RE: Permit 624 – 2013/2014 Annual Report Bond Meeting

RE: Permit 624, 2014 Reclamation Performance Bond and Reclamation Plan Revision

GOOD MINING COMPANY, LLC
PERMIT PT-624, 2014-2015 ANNUAL REPORT
Summary Information

2014 – 2015 Permit 624 Annual Report Bond Estimate

BRIAN GOOD PERMIT #624(S)
PERMIT AMENDMENT AUGUST 12, 2015
BIG HORN COUNTY, WYOMING
 Township 53N, Range 93W

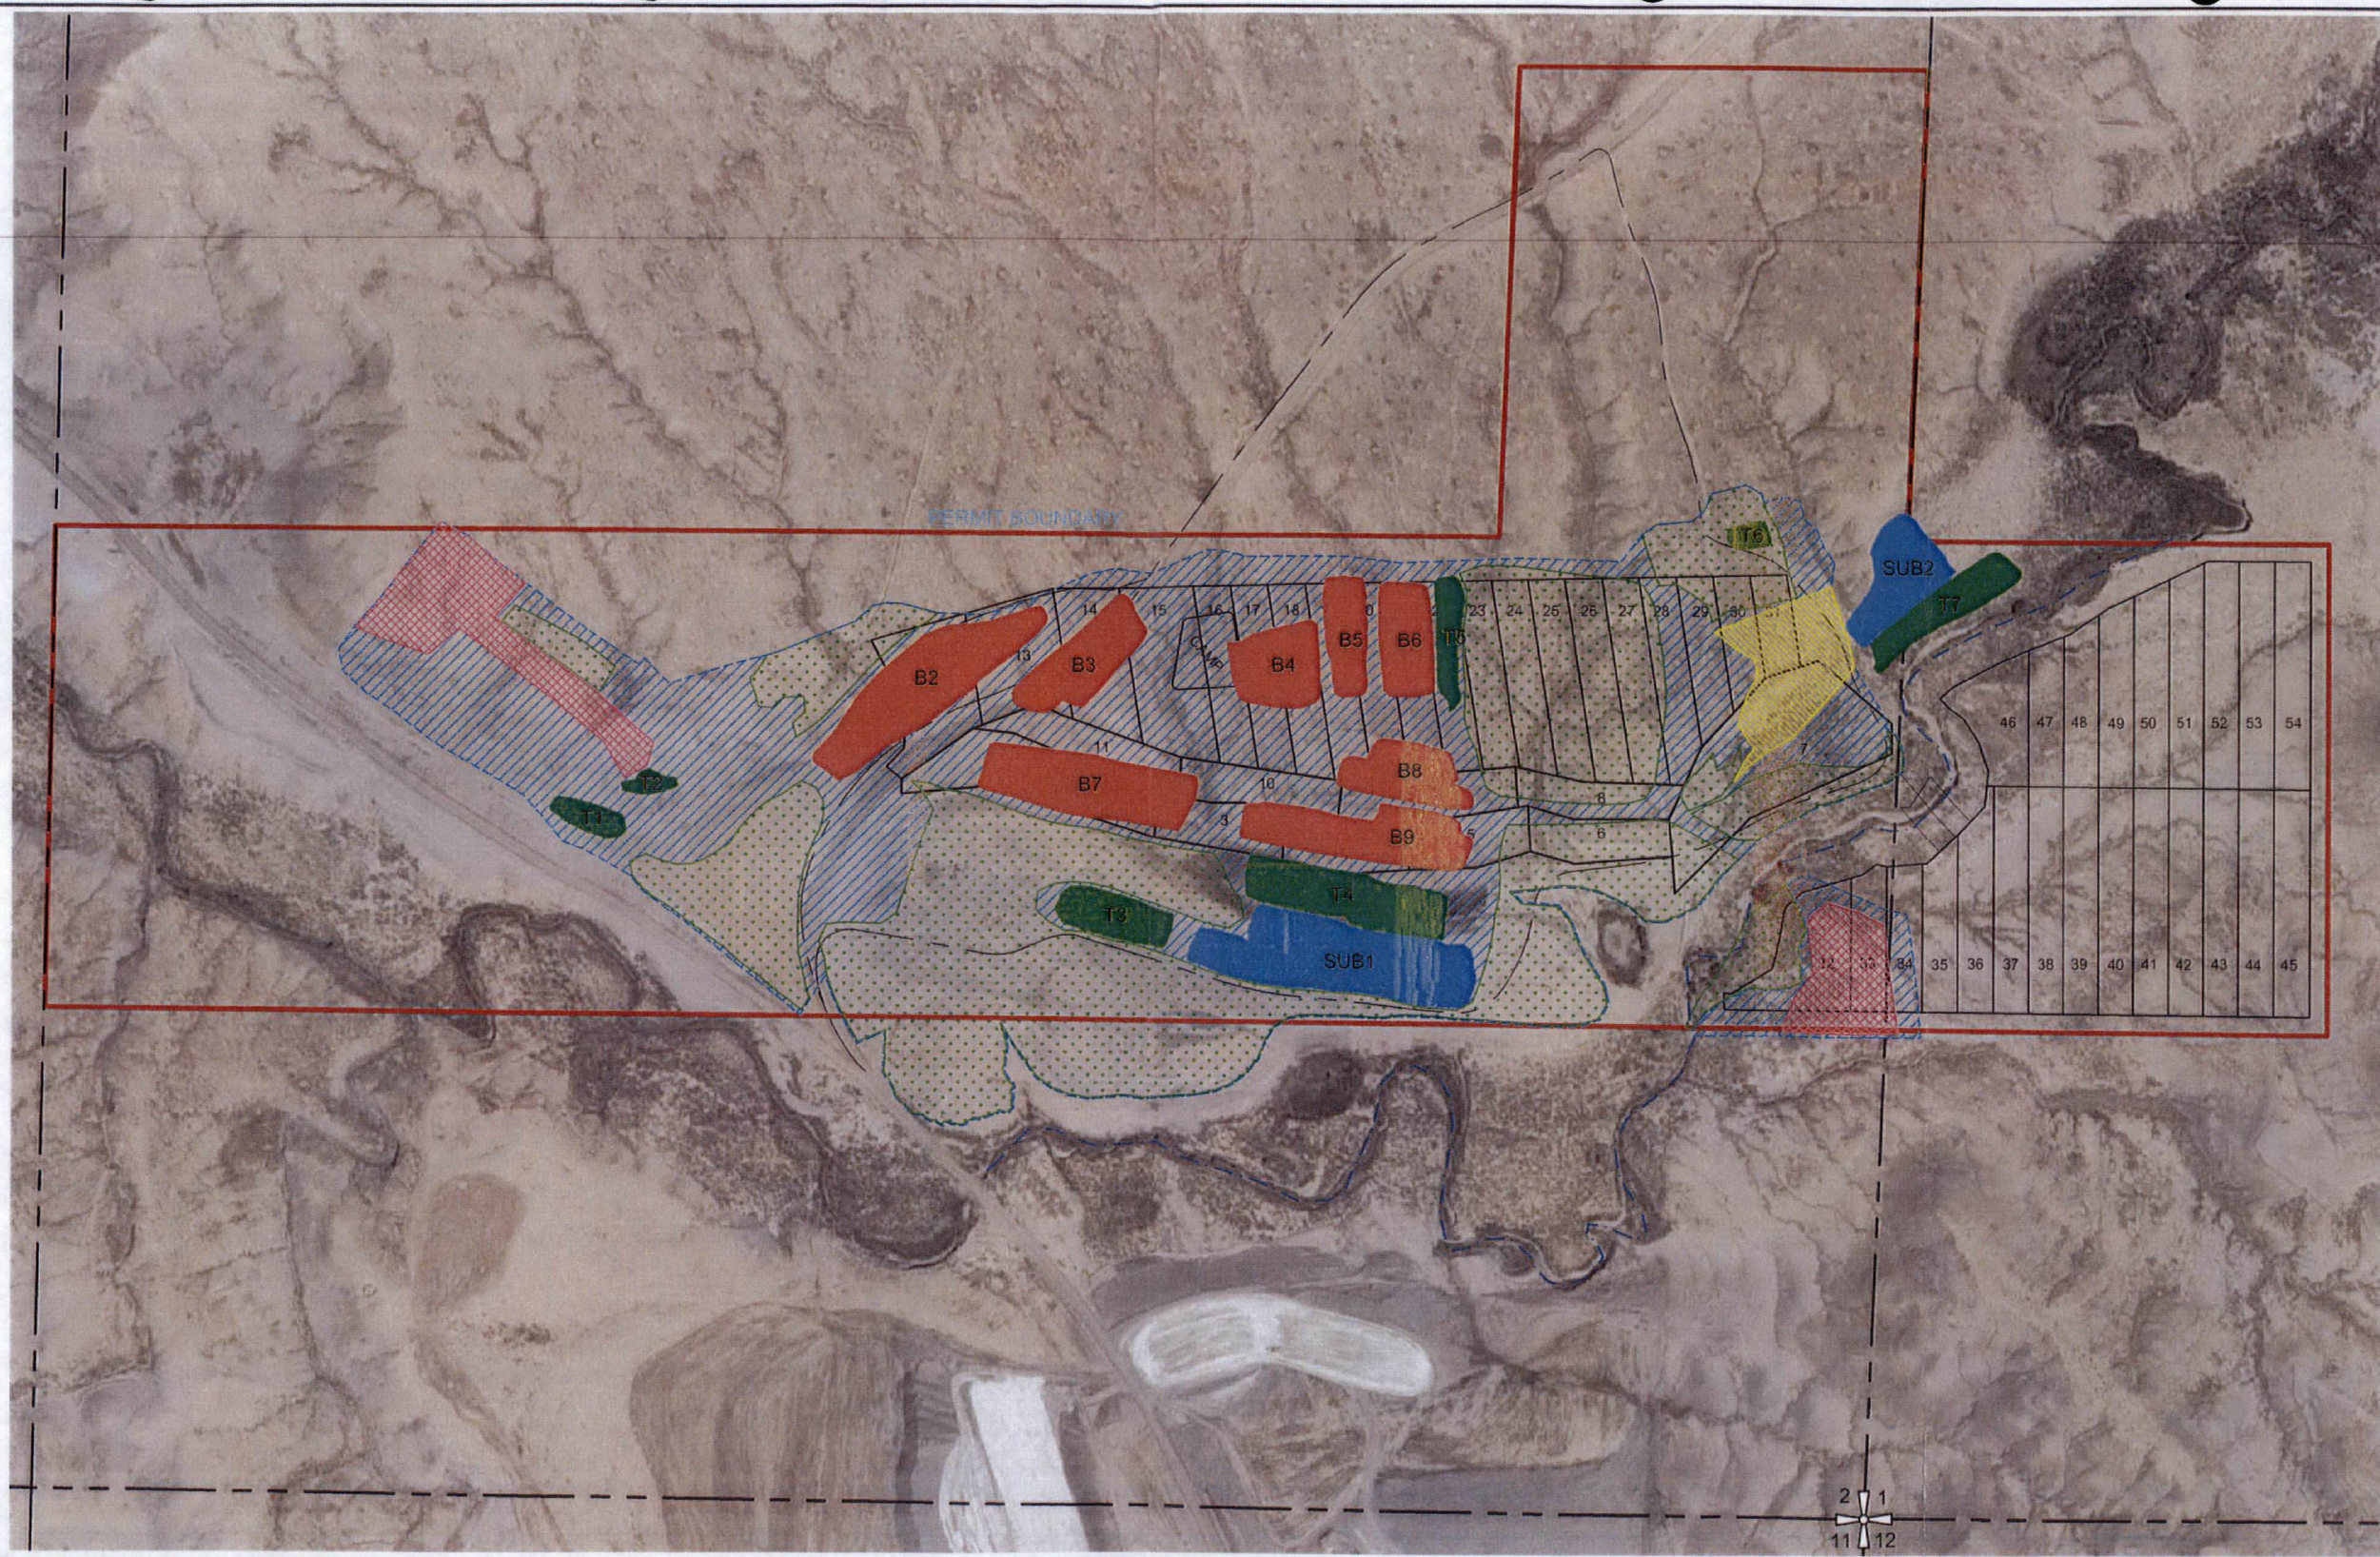
1. Retainage acreage. Based on the information presented there is an increase in the reclaimed acreage since the last report. The attached map illustrates the areal extent of ground which was identified as prelaw disturbance by Ken Tanner and is shown on Exhibit RP-1 of the approved Reclamation Plan. Some of this area has been soiled and seeded for which the WDEQ/LQD has acknowledged no reclamation liability. Of the 41.1 acres of reclamation, liability is now associated with 22 acres, not 8.9 acres.

2. I am placing caveat on this comment as my statements are based on site conditions observed last year. I believe during last year's bond discussions that it was my contention that a portion of the disturbed area was not to final grade as all of the native drainages were not reconnected (general alignments area shown on the attached map) to allow the "Tanner" pond to function. Please explain what is area is being included in the 27.3 acres identified for *Site Grading*.

Permit 624 - Inspection Map

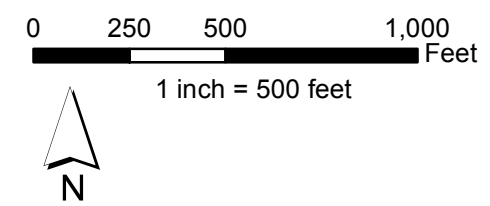
A portion of Permit 624 was disturbed prior to the passage of the Open Cut Land Reclamation Act (OCLRA) of 1969. Much of the “Pre-Law” area (areal extent shown on the attached map) was not directly re-affected by mining activity. In other words, it was used for ancillary purposes such as an equipment camp site or storage. As indicated in the approved Reclamation Plan, there is no revegetation liability associated with the Pre-Law area. As shown on the attached map, much of the Pre-Law area has been reclaimed; if the reclamation in these areas is successful and there is an area where a revegetation liability exists that is not successful, a land exchange is possible.

Two problem areas were noted during the inspection. The first is located around the perimeter of the West Pit. **Photo 4** shows the inadequate buffer zone between the end / high wall crest and the adjacent native ground. The second area noted is shown in **Photo 7** where it appeared some Soil was randomly bucked up into a corner near the creek crossing. This material should either be picked up and added to an existing Soil stockpile or picked up and used during GBC's next "live spread" operation. Topsoil / Subsoil signs were not observed on all piles; all Soil piles should be identified as required under NonCoal Rules and Regulations, Chapter 3, Section 2 (c)(i)(D).
